MIL-C-17587B(SH)
AMENDMENT 3
4 March 1994
SUPERSEDING
AMENDMENT 2
29 April 1987

MILITARY SPECIFICATION

CIRCUIT BREAKERS, LOW VOLTAGE, ELECTRIC POWER, AIR,
OPEN FRAME, REMOVABLE CONSTRUCTION

FIGURE 13A. Time-current characteristics curve for circuit breaker types ACB-2000LRC, ACB-3200HR, and ACB-4000HR.

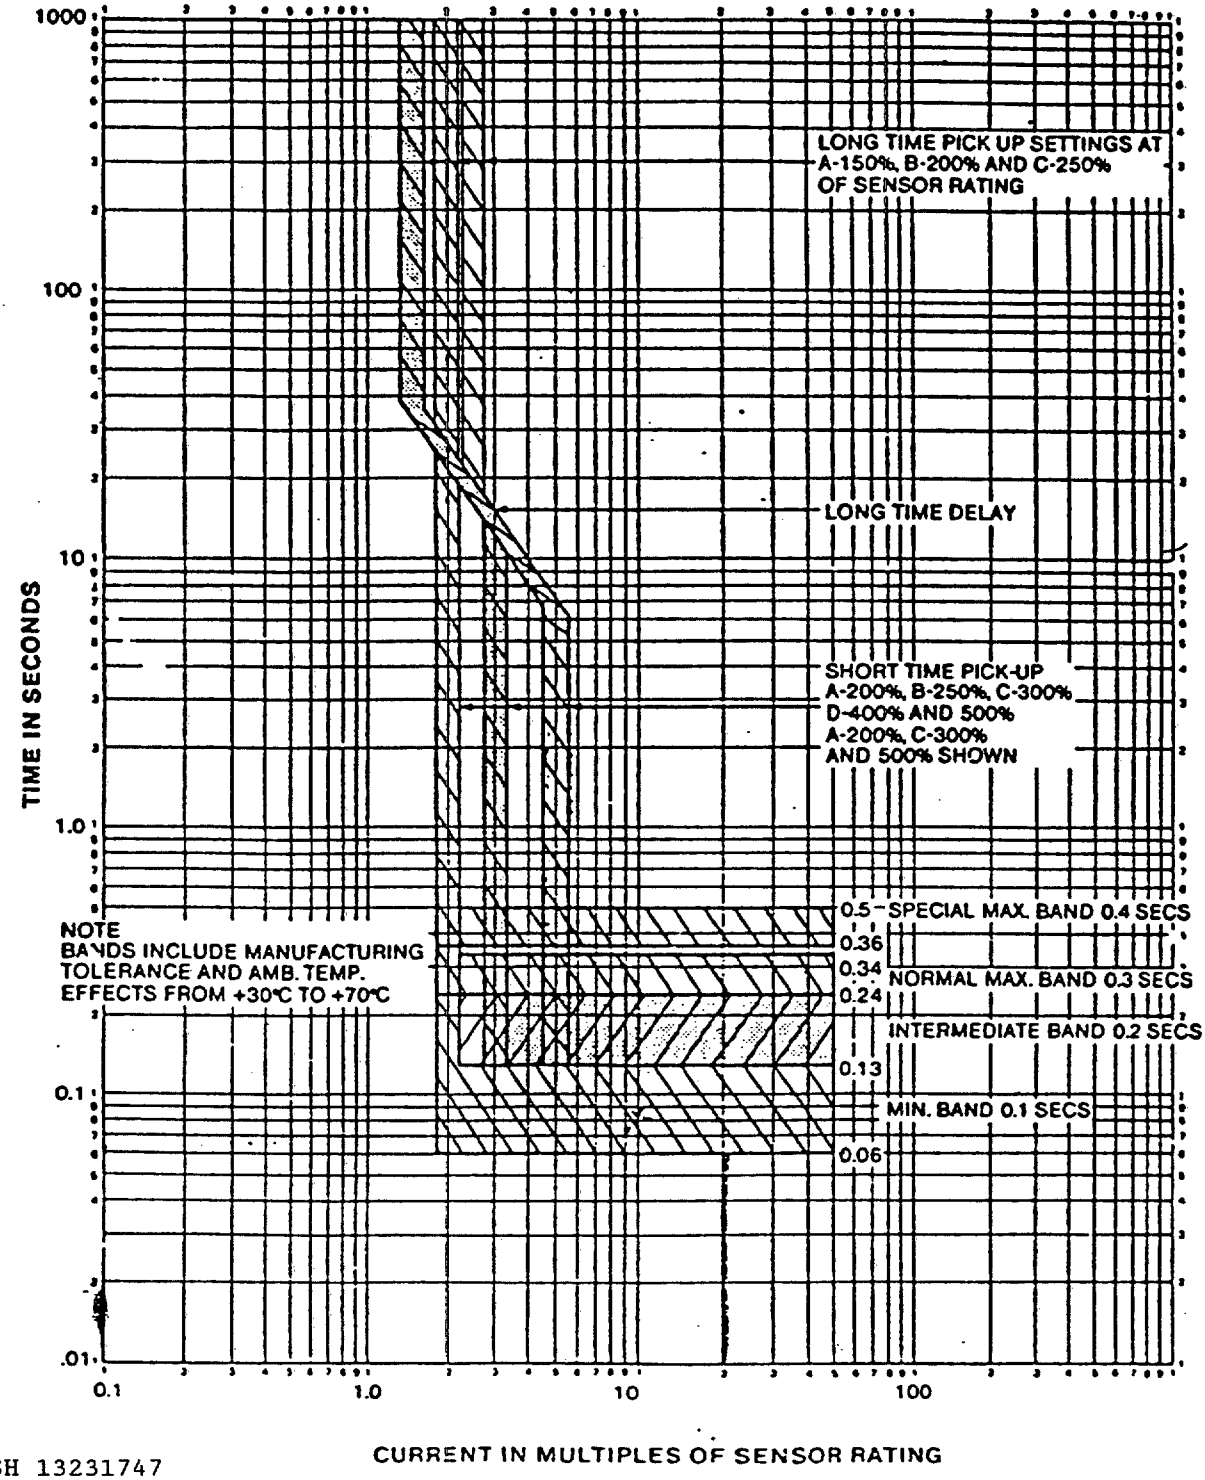
Add new figure:

FIGURE 14A. Time-current characteristics curve for circuit breaker types ACB-904LRC, ACB-1404LRC, and ACB-1604LRC.

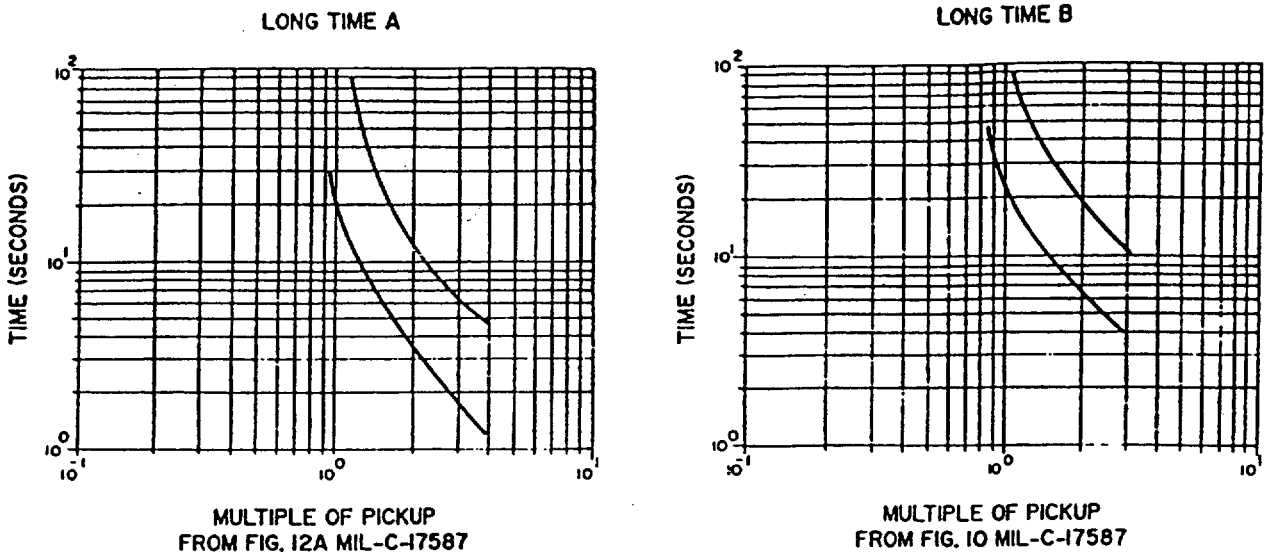
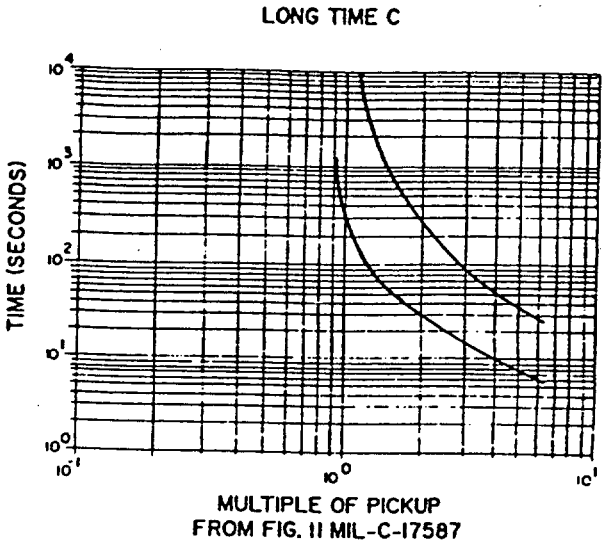
* Add new figure:

FIGURE 14A. Time-current characteristics curve for circuit breaker types ACB-904LRC, ACB-1404LRC, and ACB-1604LRC - Continued.

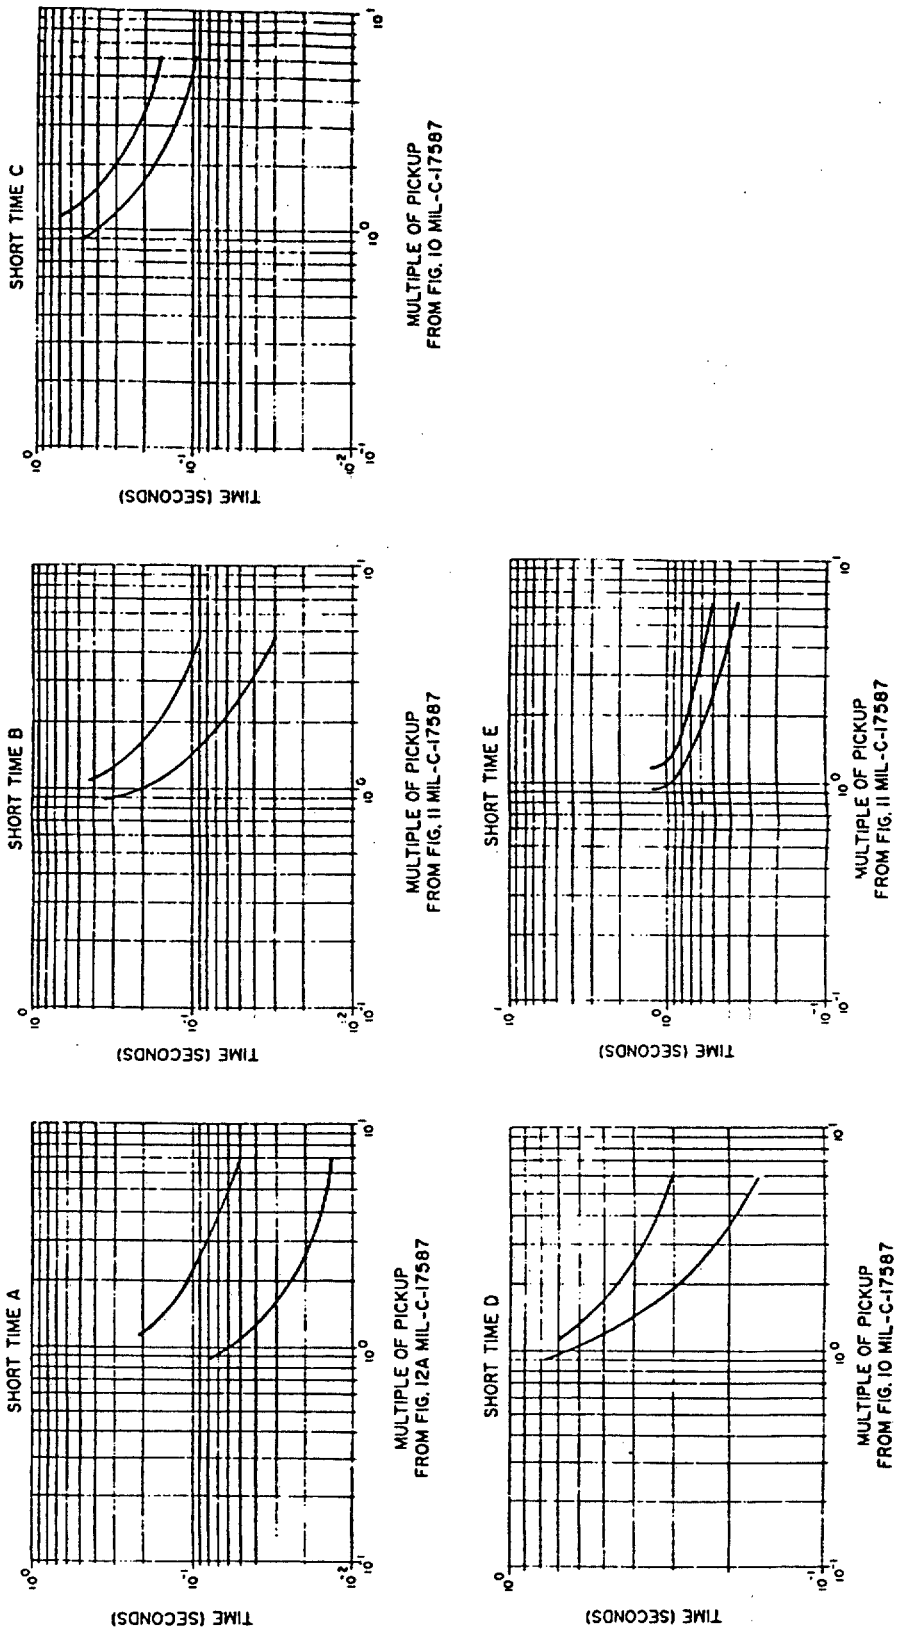
* Add new figure:
